Access Compliance Report

Public Rights-of-Way

(Curb Ramps)

Intersection ID: 28108	Main Street: BERITSTRASSE_CT	Cross Street: DARBY_CHASE_DR	Location: SE
ADA ID: BBF91562EFF3	Ramp Type: BlendTrans2	Initial Pass/Fail: Pass	Overall Compliance: No
Severity Score: 10			
Codes/Mitigation Info/Possible Solution		Field Measurements/Component Compliance

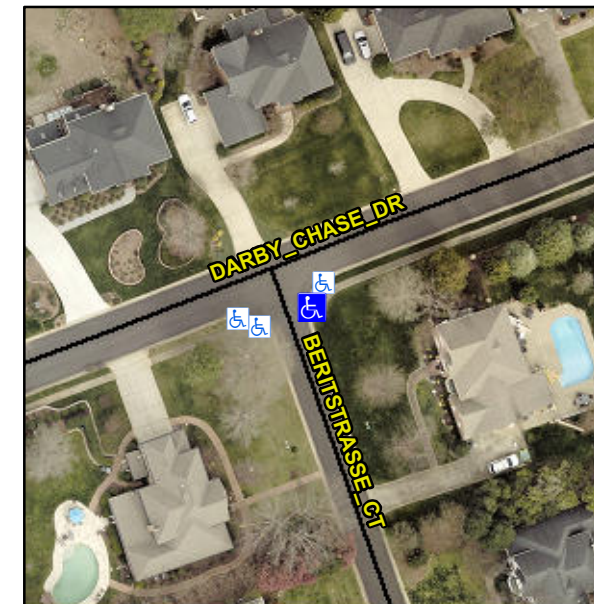
GTR GAP 1.5

Not Found, R305, R304.5.3

Remove & Replace Curb Ramp With Two New Directional Ramps or Equivalent. Remove & Replace Gutter.
